# Site Accessibility Evaluation

**EPC Public Health South**

**6436 S U.S. Hwy 85 87  
Colorado Springs, CO  
80817**

**Accessibility Evaluation**

### Finding: 3

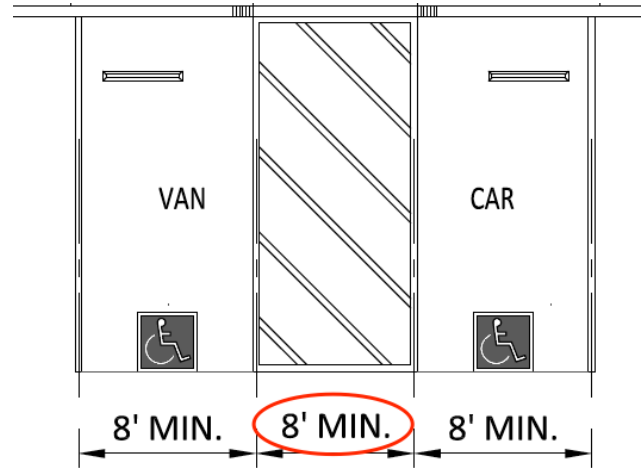
The access aisle is not a minimum 8 feet to the centerline of the stripe.

The accessible parking stall access aisle must be a minimum of 8 feet wide measured from centerline to centerline.

Designated access aisle not van accessible

Ensure van access aisle is a minimum of 8 feet wide.

### Finding: 4

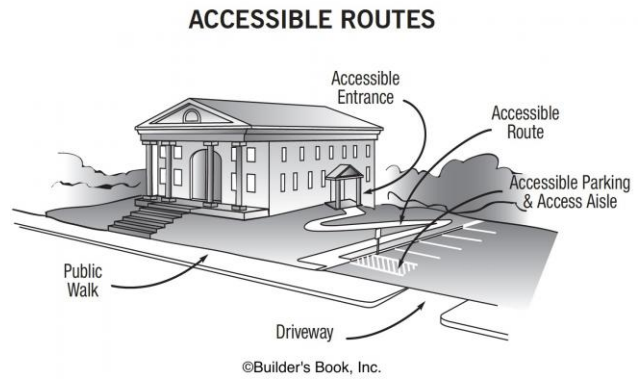
The access aisle is not located on an accessible route of travel to the accessible building entrance.

Accessible route from parking lot not defined

Ensure a designated path of travel from the access aisle to the front entrance is well defined.

### Finding: 5

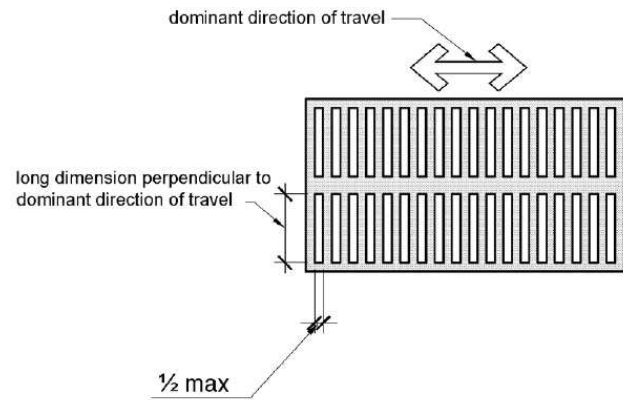
The concrete expansion joint is spaced greater than 1/2 inch.

Ground surface  
openings exceed the  
1/2 inch maximum

Elongated openings and/or expansion joints shall not be greater than 1/2 inch. Back fill ground openings greater than 1/2 inch along path of travel up to front entrance of building.

### **Finding: 7**

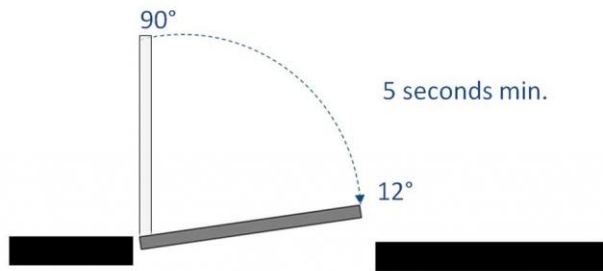
The door is equipped with a door closer and returns to a closed position too quickly.

3.82 seconds to closed position

Adjust both door closers to allow a minimum of 5 seconds to move from the open position at 90 degrees to 12 degrees from the latch/locking mechanism.

### Finding: 9

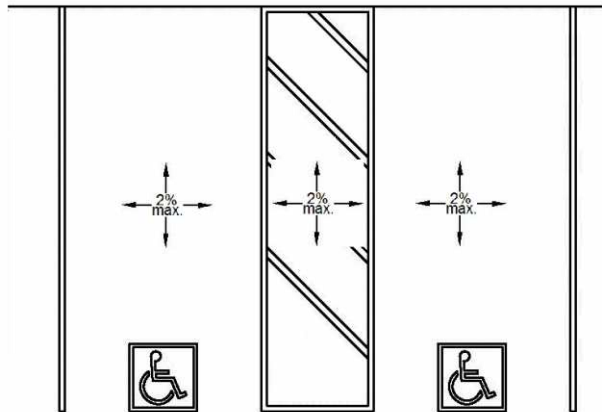
The running slope (long dimension) of the accessible parking stall exceeds 2%.

Running slope  
between 2.4 % and 3.8  
%

Re-stripe ADA parking stall/s and access aisle/s. ADA parking stalls shall measure 8 ft minimum in width measured to the centerline of the paint stripes. Access aisles shall measure 5 ft minimum in width measured to the centerline of the paint stripes. Ensure ADA van parking stall/s are 8 feet wide minimum with an access aisle of 8 feet wide minimum or 11 feet wide minimum with an access aisle of 5 feet wide minimum measured to the centerline of the paint stripes.

### Finding: 10

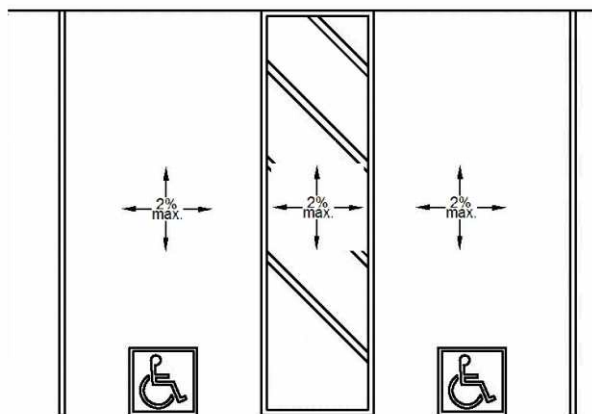
The running slope of the access aisle (long dimension) exceeds 2%.

Running slope  
between 2.2 % and 3.5  
%

Re-stripe ADA parking stall/s and access aisle/s. ADA parking stalls shall measure 8 ft minimum in width measured to the centerline of the paint stripes. Access aisles shall measure 5 ft minimum in width measured to the centerline of the paint stripes. Ensure ADA van parking stall/s are 8 feet wide minimum with an access aisle of 8 feet wide minimum or 11 feet wide minimum with an access aisle of 5 feet wide minimum measured to the centerline of the paint stripes.

### Finding: 12

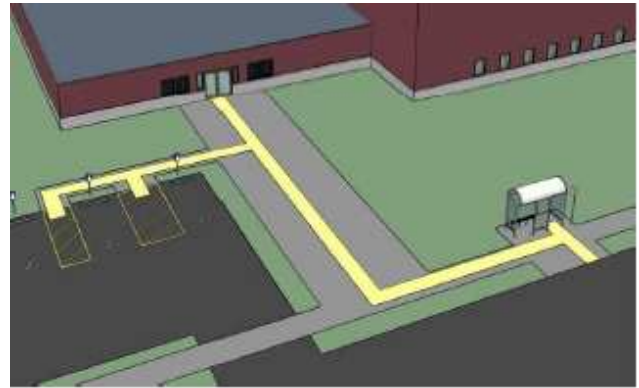
The accessible parking is not located on an accessible route of travel to the accessible building entrance.

Accessible path of travel to west entrance not defined

When accessible parking stalls are to be constructed/identified ensure an accessible path of travel is designated and defined.

### Finding: 13

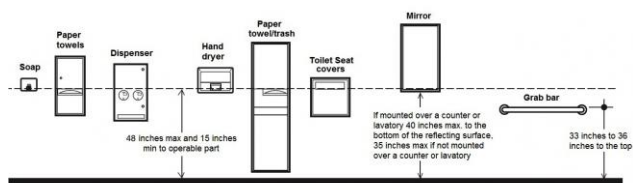
The paper towel dispenser's operation mechanism is too high off the floor.

Paper towel dispenser  
54 inches above  
finished floor

Reposition paper towel dispenser adjacent to lavatory. Recommend replacing existing dispenser with low profile dispenser. 48 inches maximum height above finished floor for operable parts (knob/sensor).

### Finding: 14

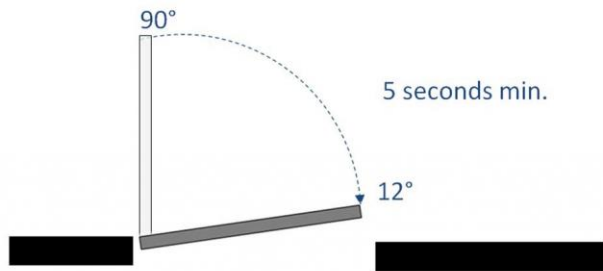
The door is equipped with a door closer and returns to a closed position too quickly.

2.68 seconds to closed position

Adjust door closer to allow a minimum of 5 seconds to move from the open position at 90 degrees to 12 degrees from the latch/locking mechanism.

### Finding: 15

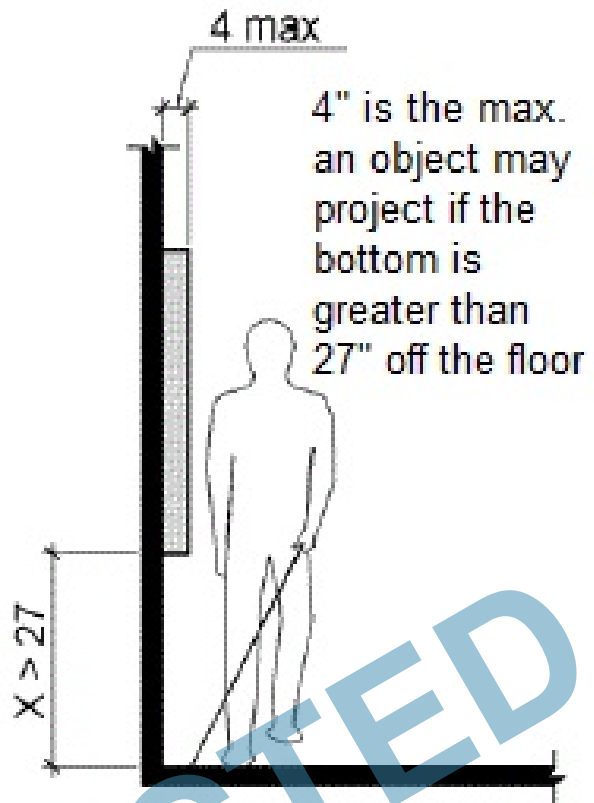
The paper towel dispenser projects more than 4 inches into the circulation path.

Paper towel dispenser  
protrudes 10 inches  
from wall

Reposition paper towel dispenser adjacent to lavatory. Recommend replacing existing dispenser with low profile dispenser. 48 inches maximum height above finished floor for operable parts (knob/sensor).

### Finding: 16

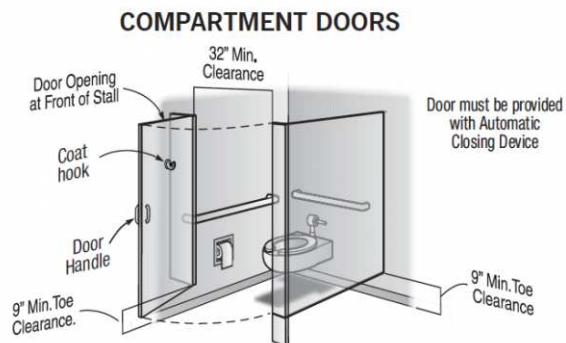
The compartment door is not self closing.

Compartment door  
does not close  
completely

Adjust or install automatic closing hinges.

### Finding: 17

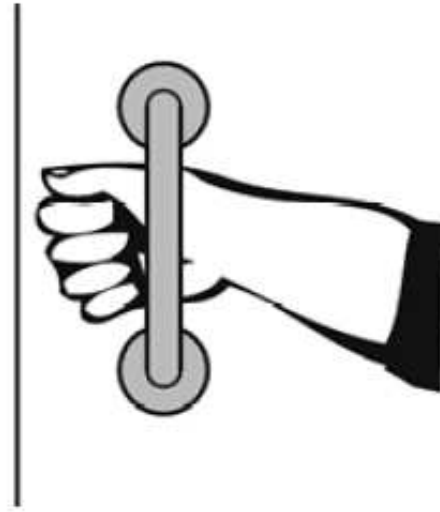
The water closet compartment door is missing a loop handle on the inside.

Missing inside loop handle

Install loop or U-shaped handle on inside of compartment door.
